Stromberg Parts Correction

Neal
cougarnfw@aol.com
July '05 filed as Stromberg parts error

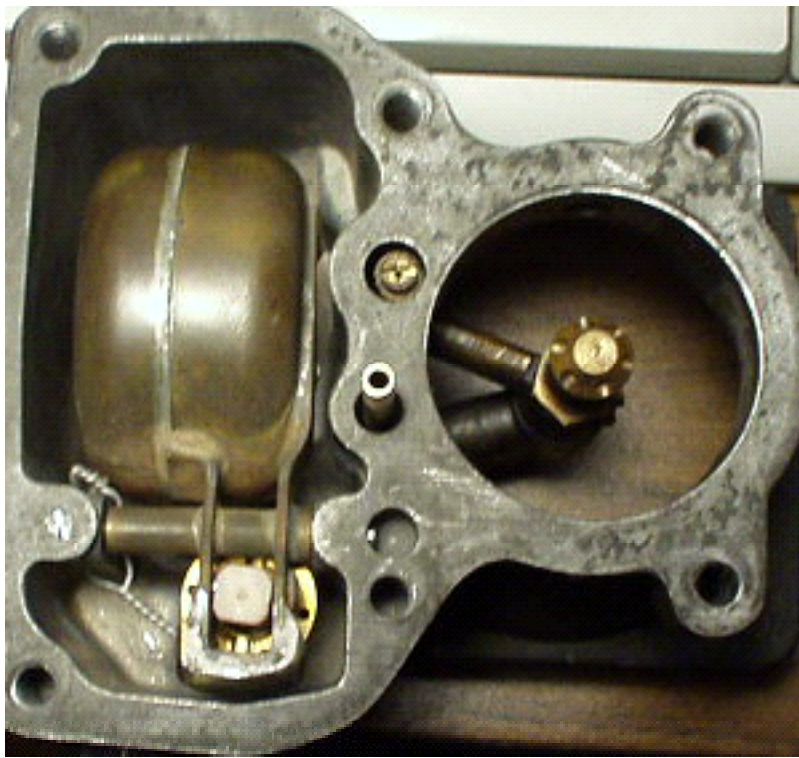
This is the top view of the bottom half of the carburetor, with the nozzle on the right and the float and needle on the left. This unit has the Delrin needle and that explains the non-symmetrical "U-shaped" item below the needle. It is the weight which must be added to the float when the Delrin is used, and only when the Delrin is used.

Note the safety wire from the casting to one of the holes in the seat. Because there are two different castings, the safety holes in the casting are in two different places.

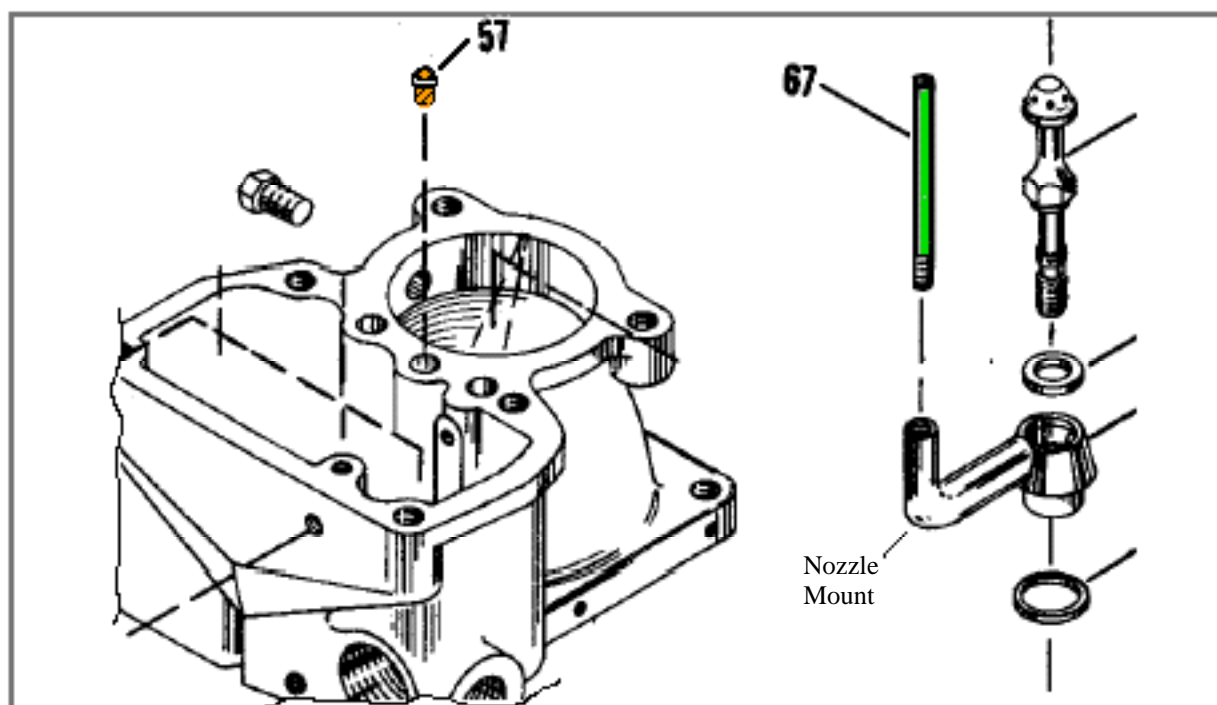
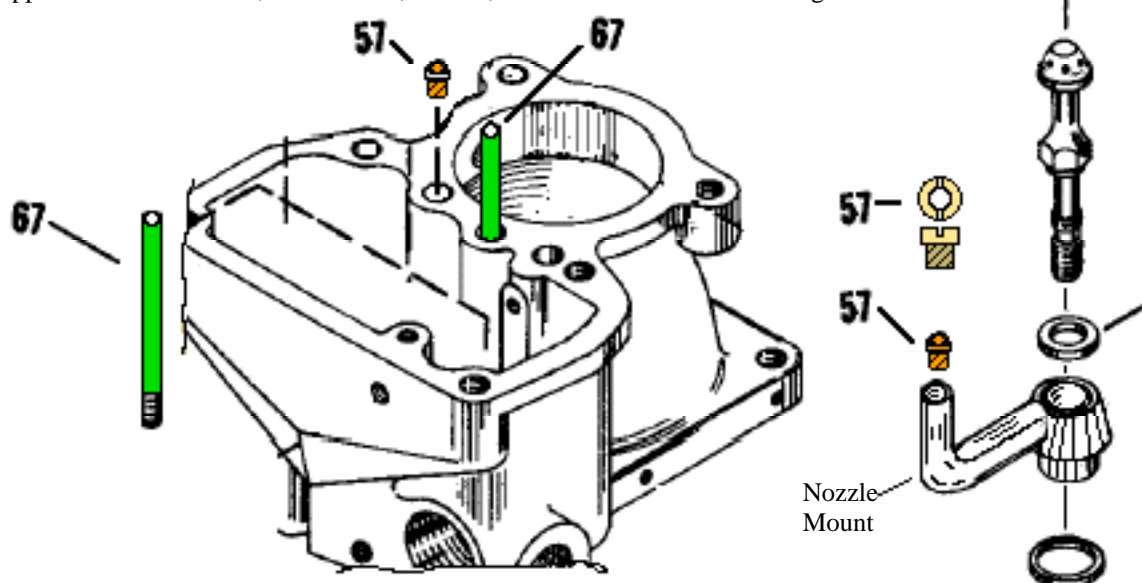
Above is the representation of the parts 57 and 67 as they appear in the Stromberg exploded view in all of the manuals and documents available to us. Item 57 is shown as going in the wrong hole, and item 67 should appear where 57 is now, and item 57, not 67, should be shown as screwing into the nozzle mount.

This is what the exploded view of the carburetor should have looked like for the parts 57 and 67 relative to where they actually appear. Here, item 57 is shown to screw into the nozzle mount on the right, and it is also shown as it appears in its correct hole on the left. Item 67 is shown twice, once in its free state and the other as it should appear in the exploded view, now projecting from its correct hole. To make clear what item 57 looks like, it has been expanded on the right with its threads, through hole of size 60, and with the screwdriver slot. If you look straight down on the this half of the carburetor, the top of item 57 is nearly flush with the top surface of the casting, with a gap around it for air.
